ISO/
IEC/IEEE
8802-3

AMENDMENT 1
2021-12

**AMENDMENT 1: Physical layer
specifications and management
parameters for 2.5 Gb/s and 5 Gb/s
operation over backplane**

IEEE Standard for Ethernet

Figure 69-4—Architectural positioning of 2.5 Gb/s and 5 Gb/s Backplane Ethernet

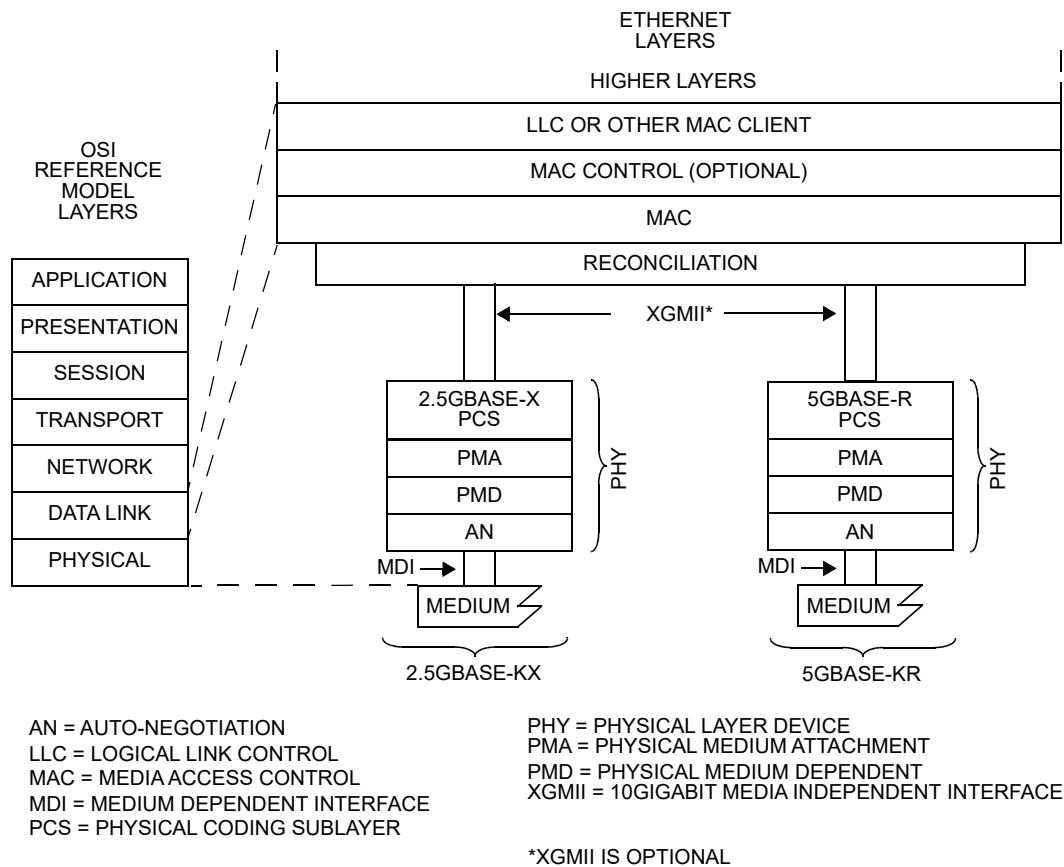
Backplane Ethernet couples the IEEE 802.3 MAC to a family of Physical Layers defined for operation over electrical backplanes. The relationships among Backplane Ethernet, the IEEE 802.3 MAC, and the ISO Open System Interconnection (OSI) reference model are shown in [Figure 69-1](#), [Figure 69-2](#), ~~and~~ [Figure 69-3](#), ~~and~~ [Figure 69-4](#).

Insert the new figure on the next page (Figure 69-4) after Figure 69-3.

Figure 73–1—Location of Auto-Negotiation function within the ISO/IEC OSI reference model

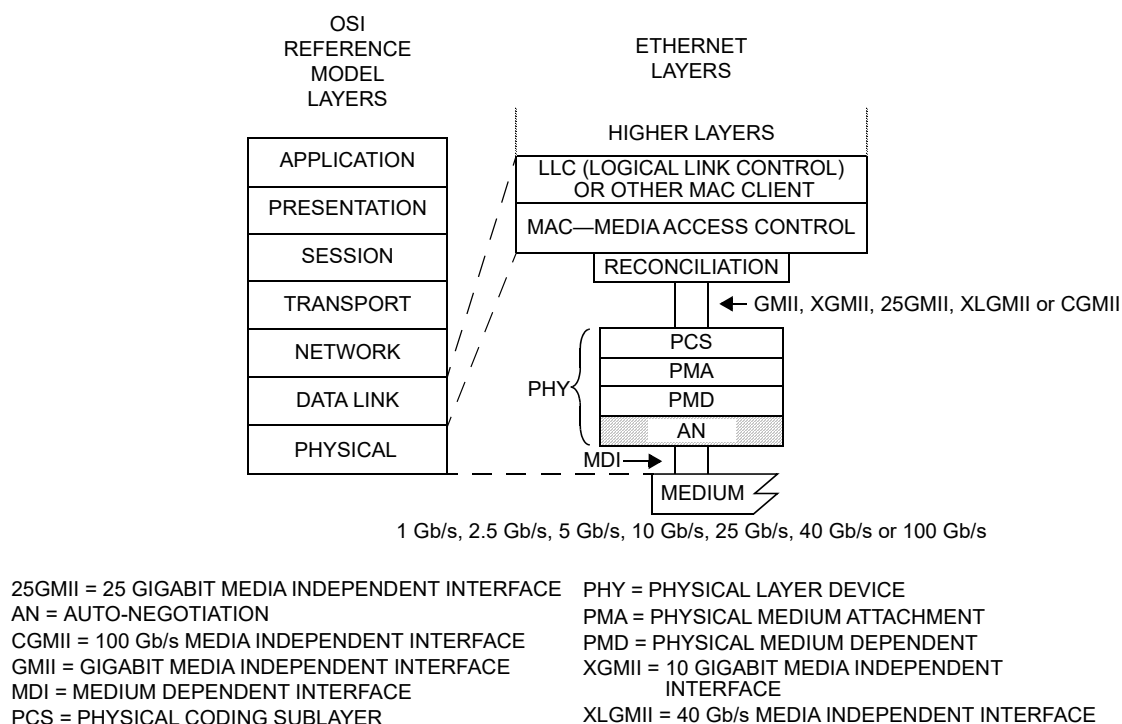
Replace Figure 73–1 with the following figure (which adds 2.5 Gb/s and 5 Gb/s in the medium rates):
